DRAINAGE SUMMARY

PROJECT : INTERSTATE ROUTE H-3

F. A. I. PROJECT NO: 1 - H-3-(150)

STATE OF HAWAII DEPARTMENT OF TRANSPORTATION HIGHWAYS DIVISION
DRAINAGE PLAN
INTERSTATE ROUTE H-3 F.A.I. PROJ. NO. I-H3-1(50)
SCALE: 1" = 40' DATE: JUL., 1988
SHEET No. H8 OF 54 SHEETS

SHEET No. H7 OF 54 SHEETS

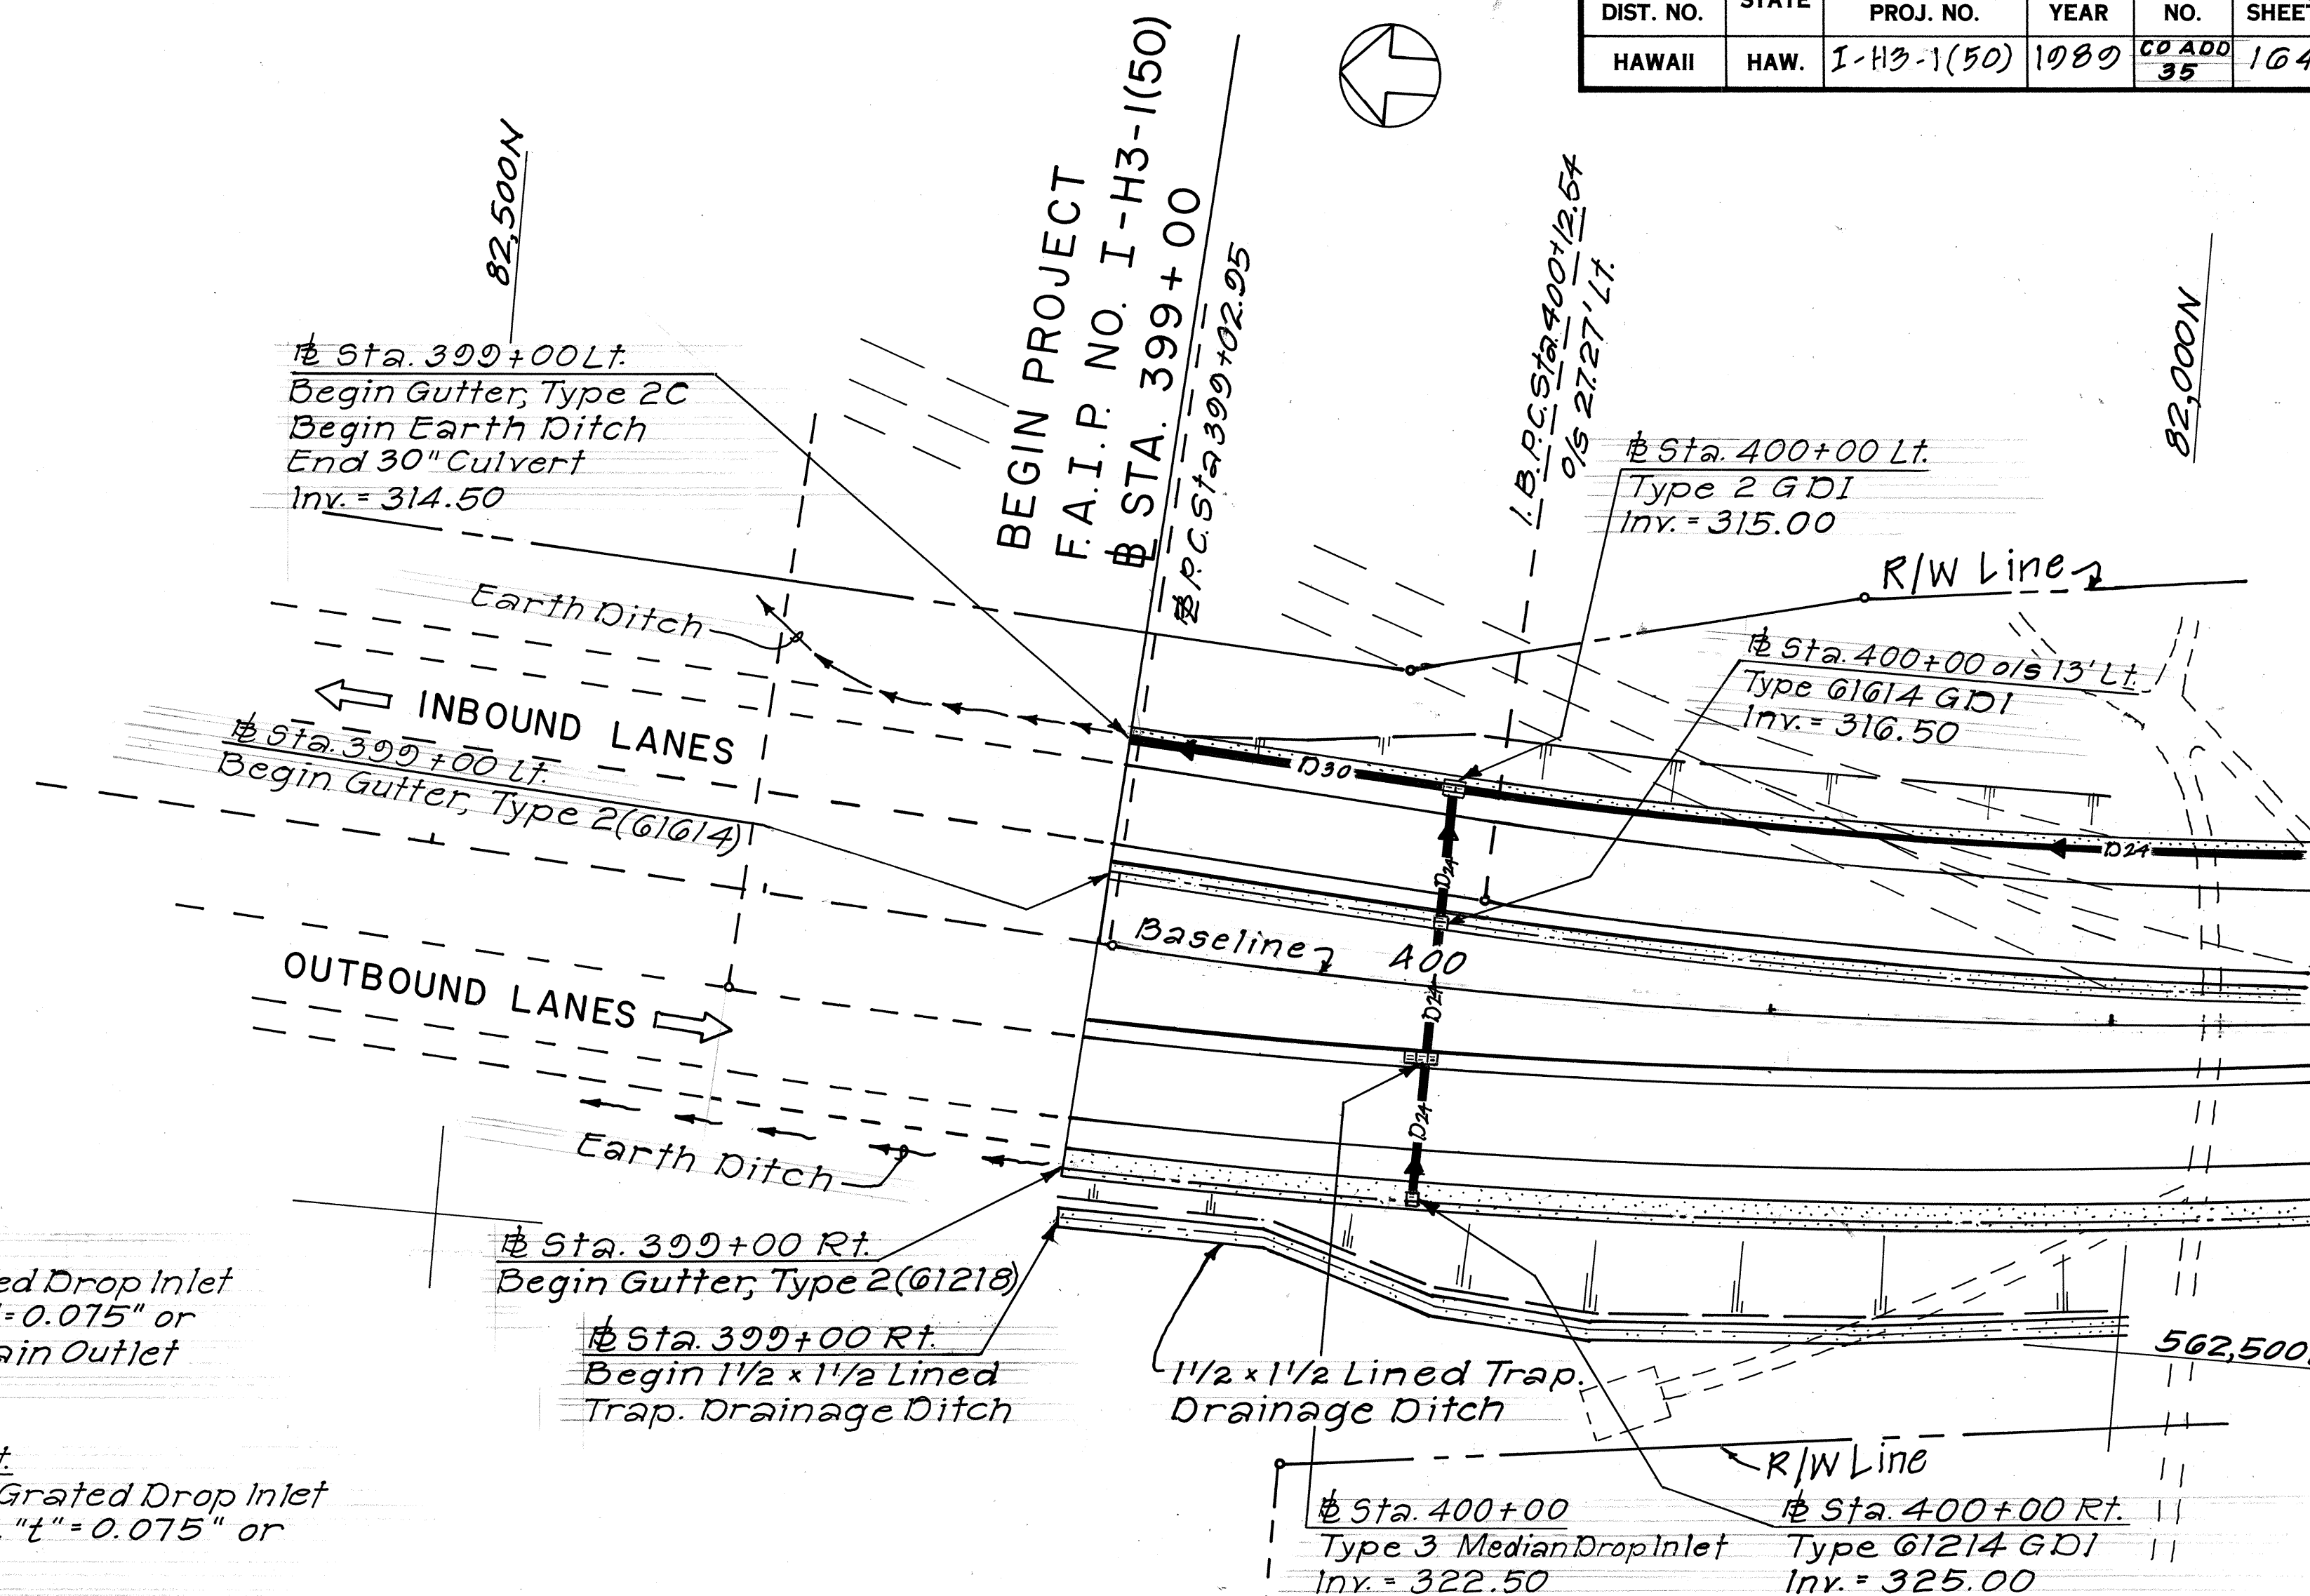
8/31/90	Add Gutters from Sta. 399+00 Rt. to Sta. 402+95 Rt., Sta. 399+00 Lt. to Sta. 402+85 Lt., and Sta. 399+00 to Sta. 405+25
1/4/89	Deleted Gutters from Sta. 399+00 Rt. to Sta. 402+95 Rt. and Sta. 399+00 Lt. to Sta. 402+85 Lt. Sta. 402+85 Lt. revised to Sta. 404+16.47 Lt. Drainage ditch limits changed from Sta. 410+25 Rt. to Sta. 411+20 Rt.
DATE	REVISION

SHEET NO. H9 OF 54 SHEETS

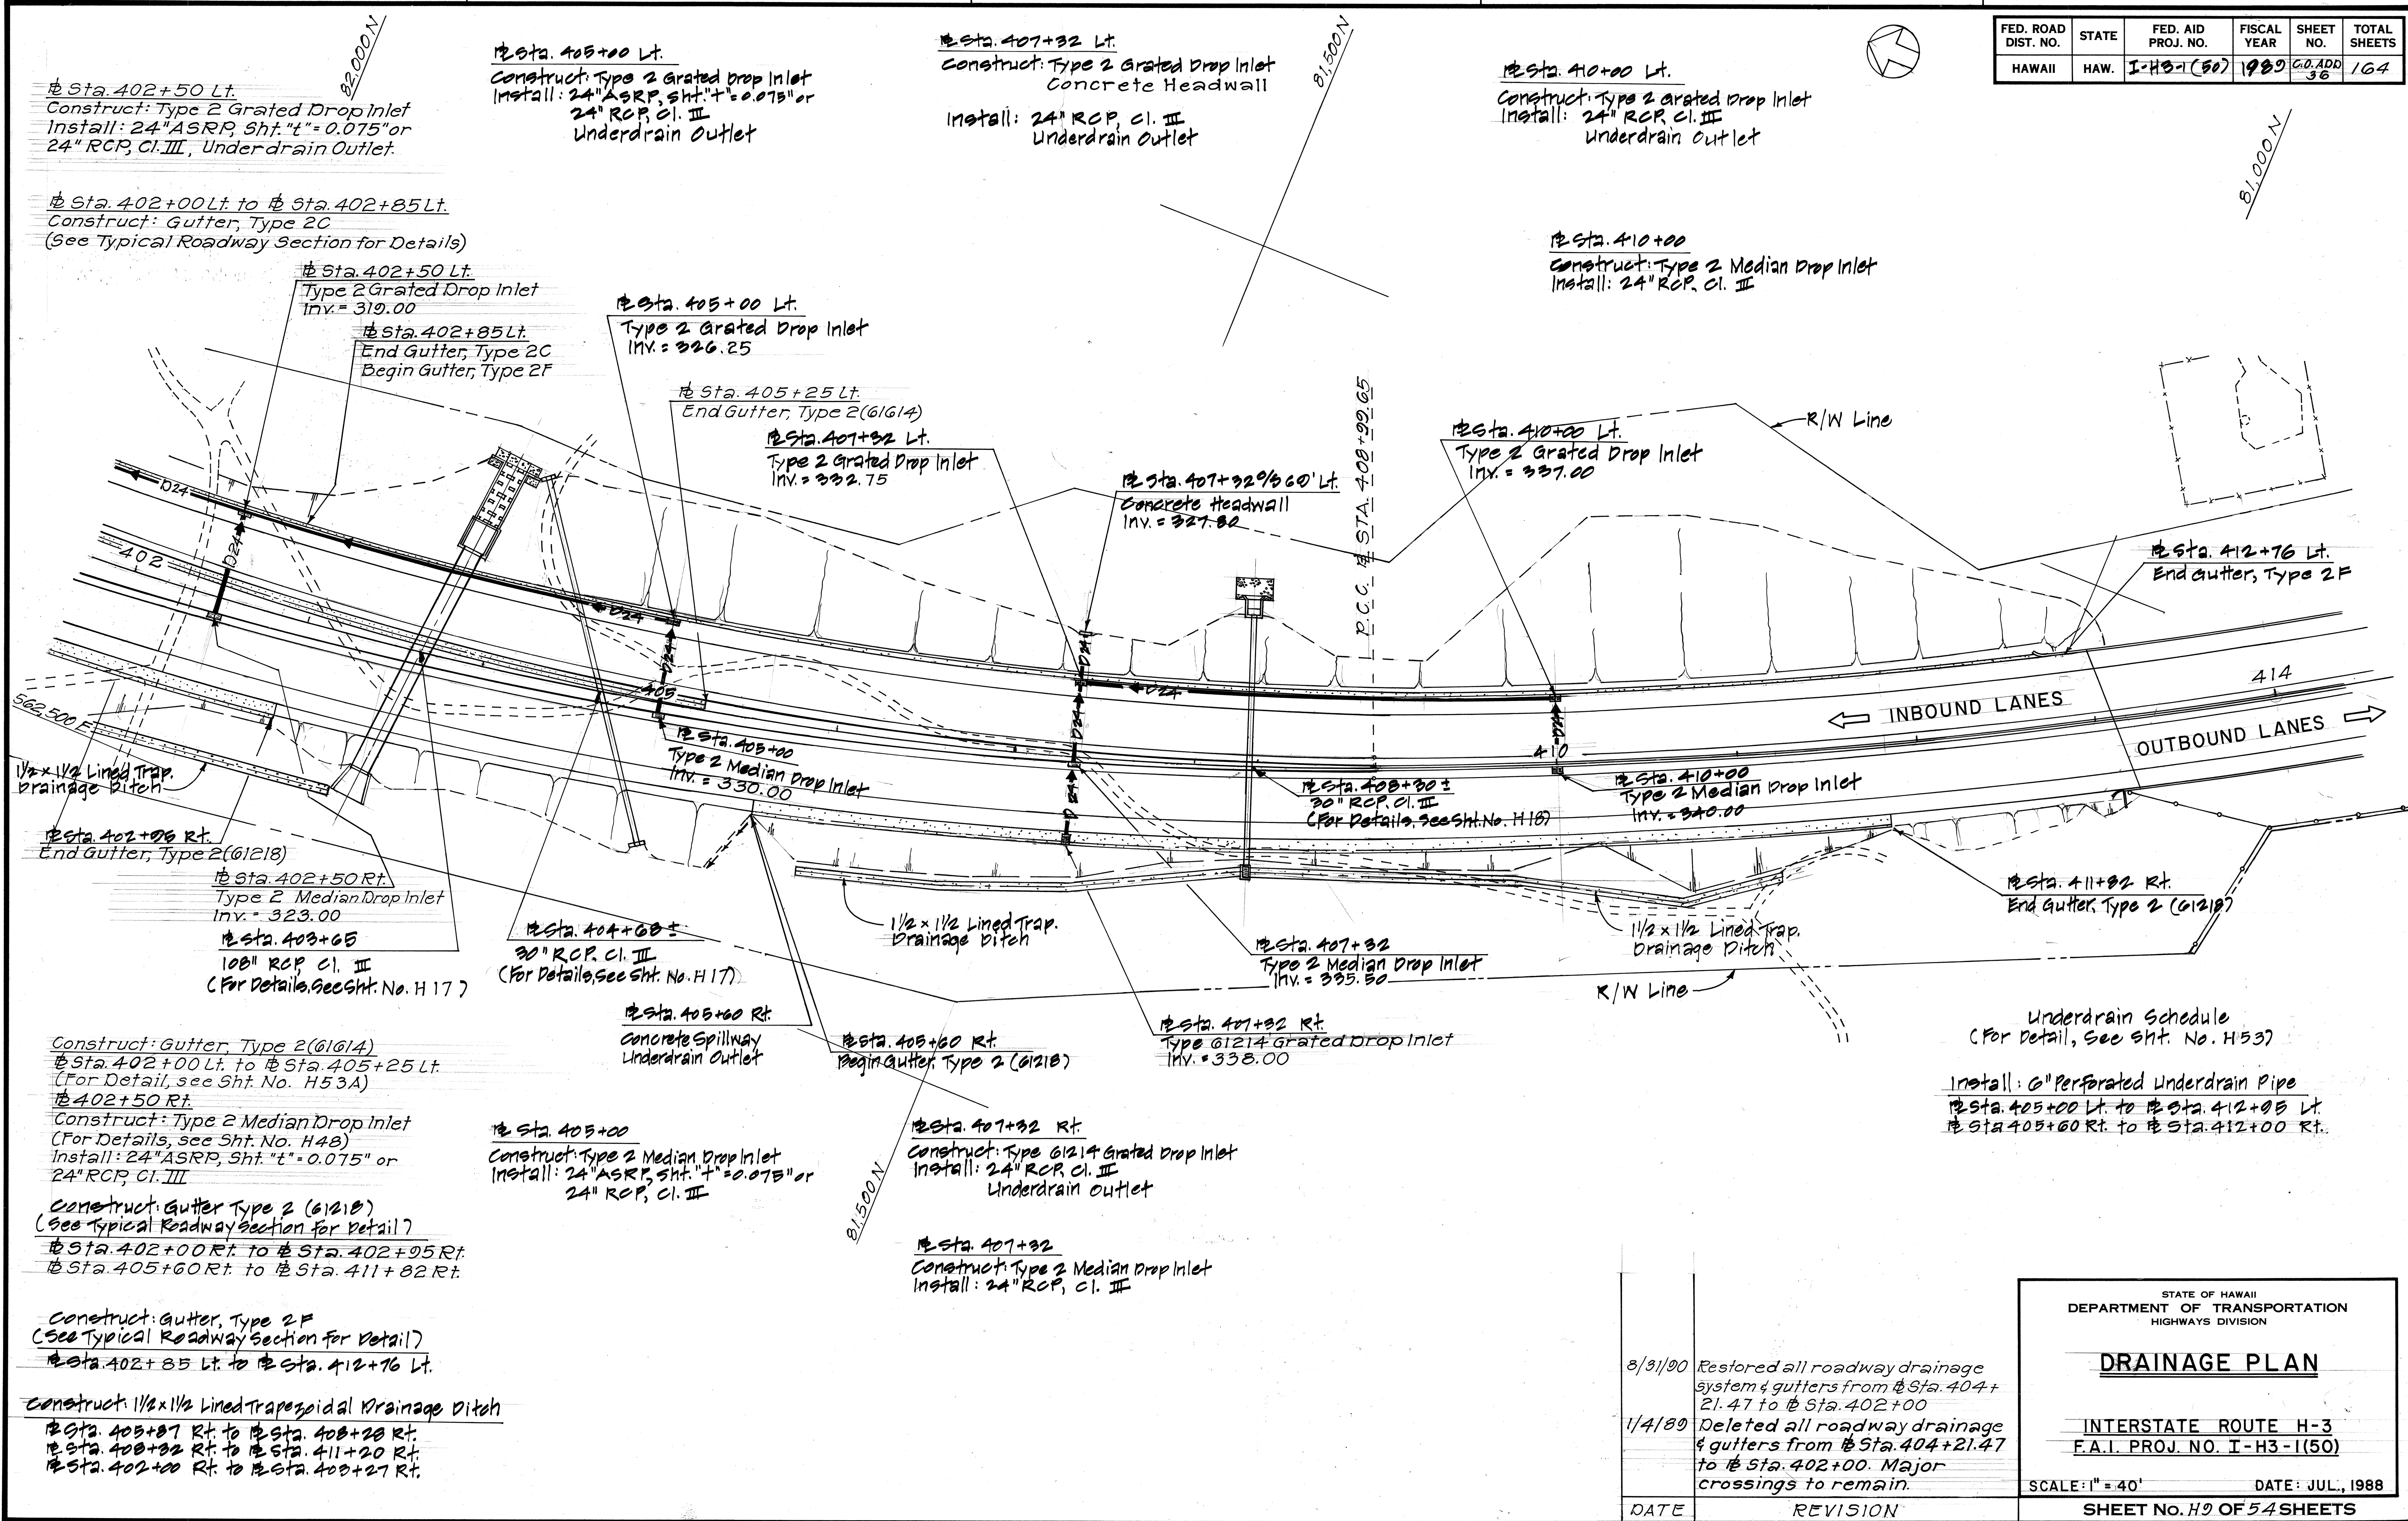
DATE	REVISION
8/31/90	Restored all roadway drainage system & gutters from Sta. 404+21.47 to Sta. 402+00
1/4/89	Deleted all roadway drainage & gutters from Sta. 404+21.47 to Sta. 402+00. Major crossings to remain.

SHEET No. H16B OF 54 SHEETS

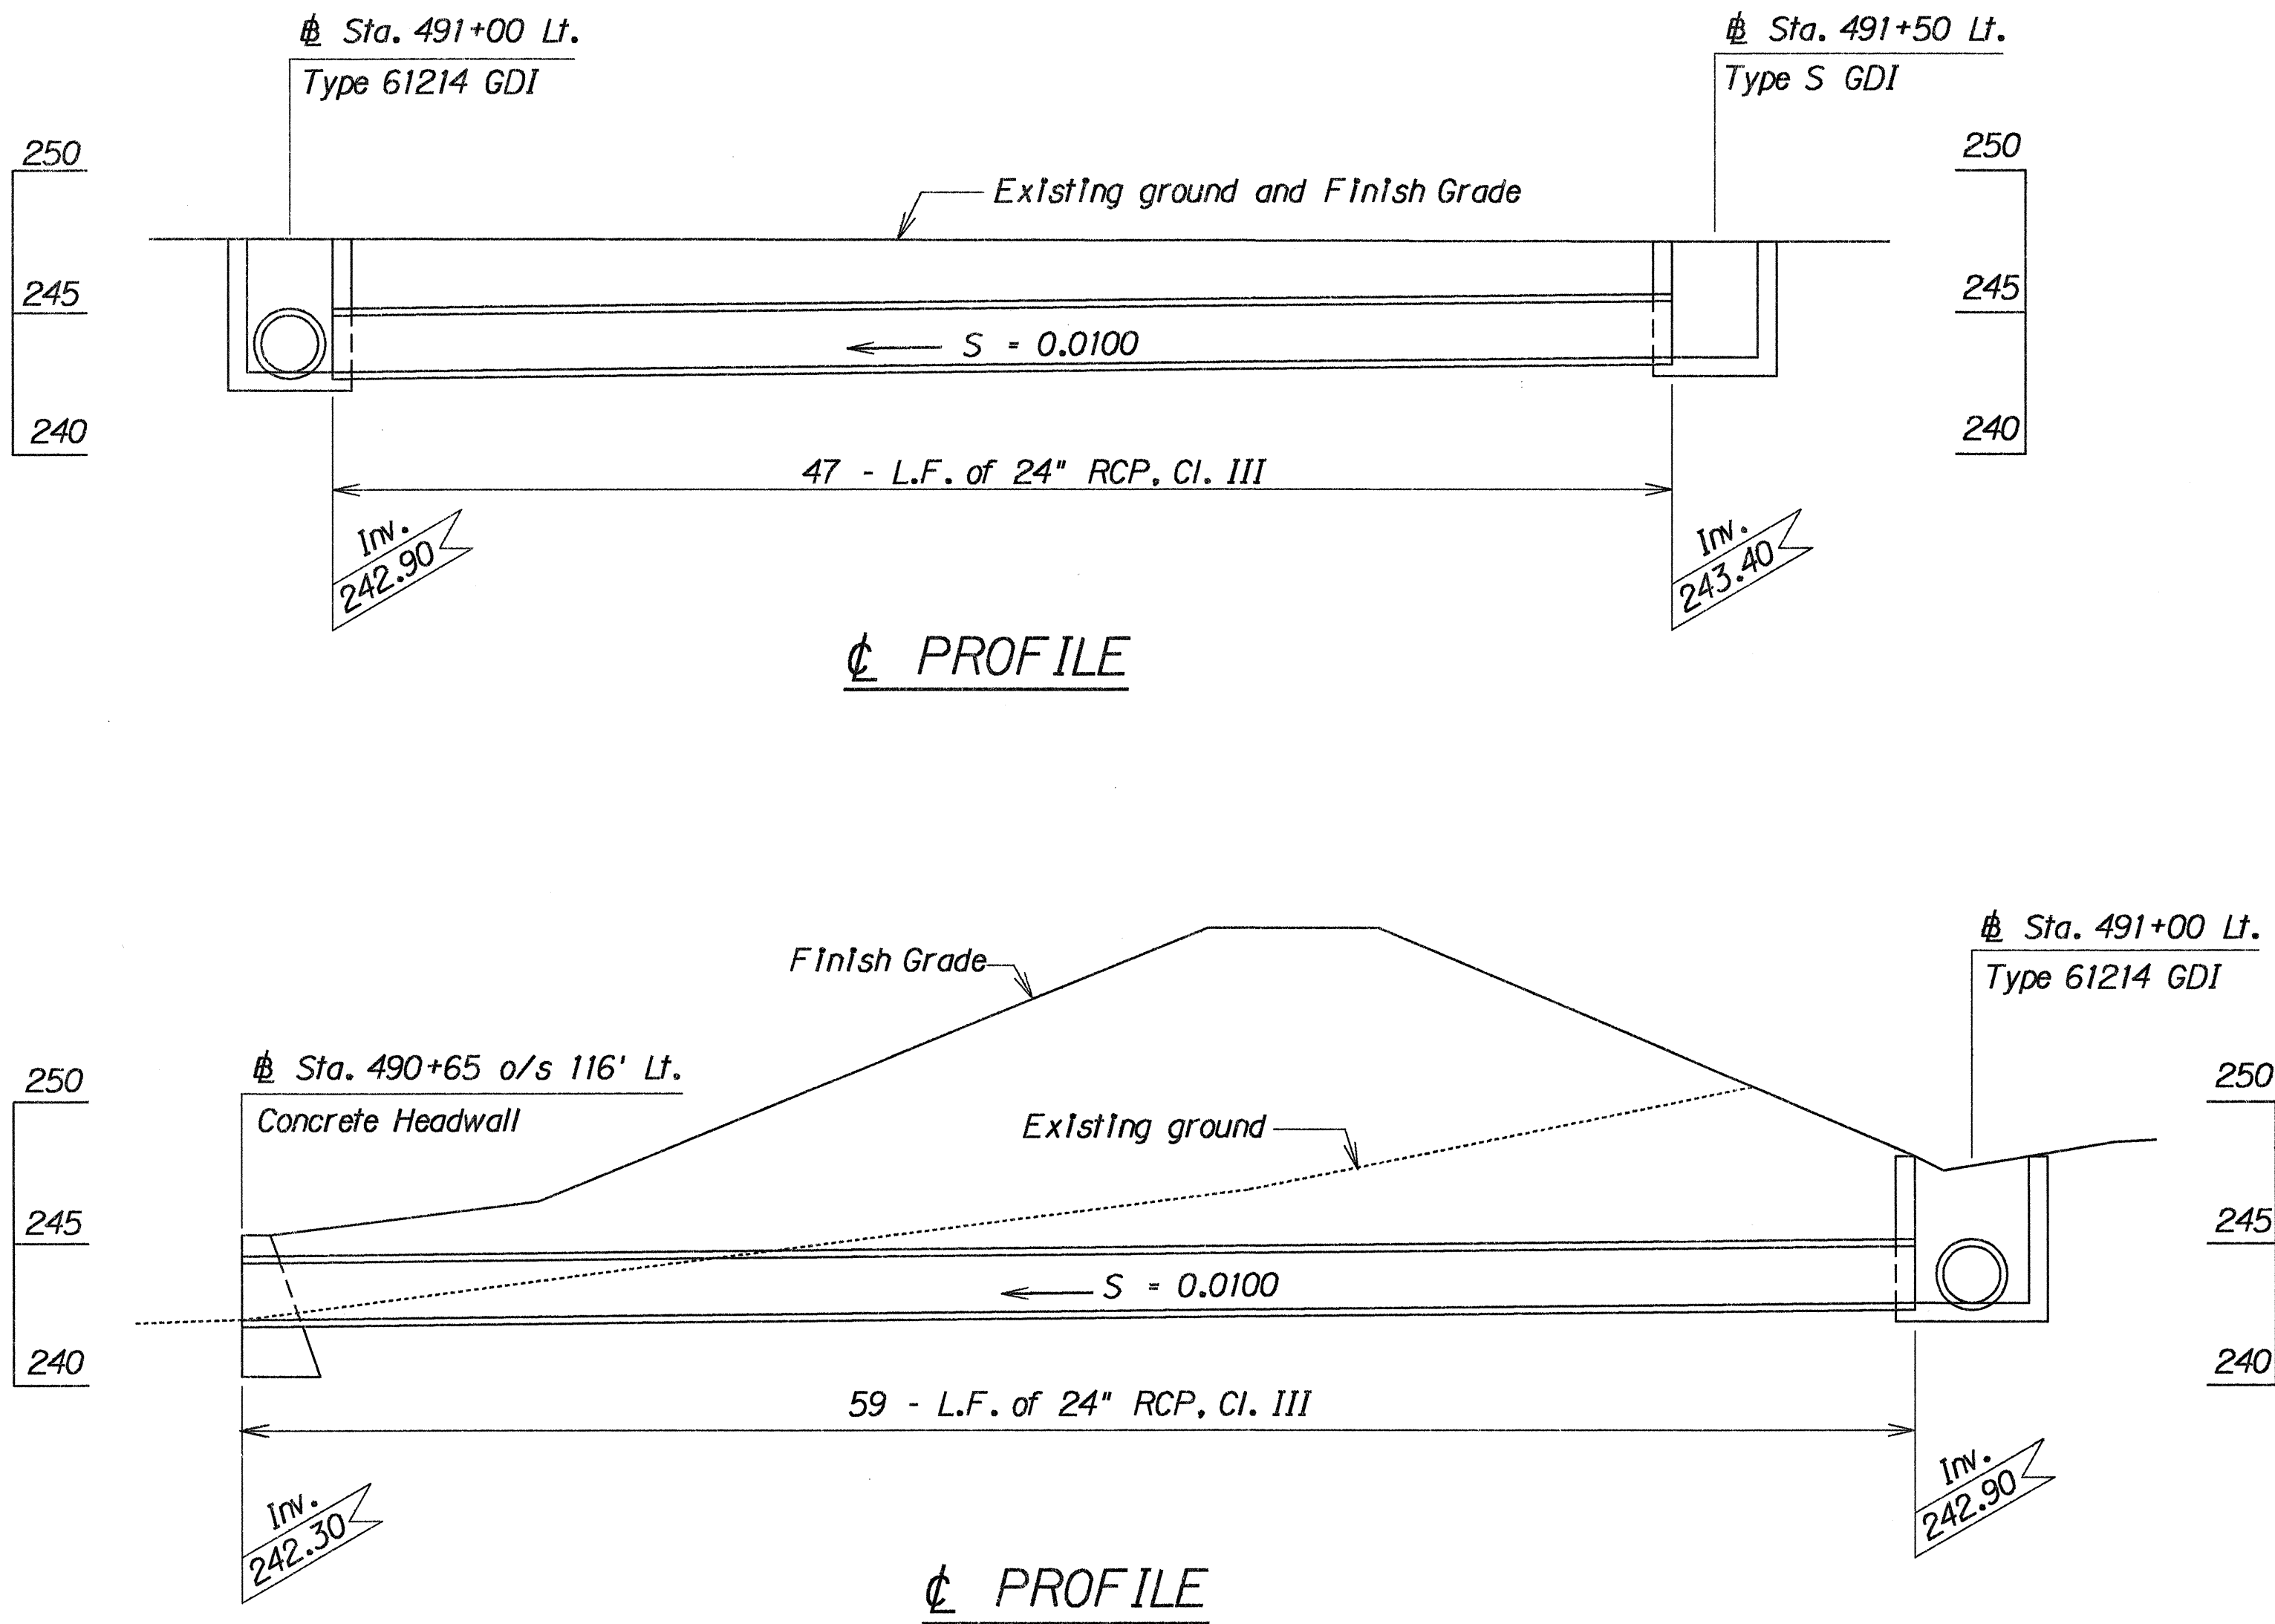
06/03/91	Sheet added to Contract Plan to show drainage improvements between ϕ Sta. 490+20 to ϕ Sta. 492+00
DATE	REVISION
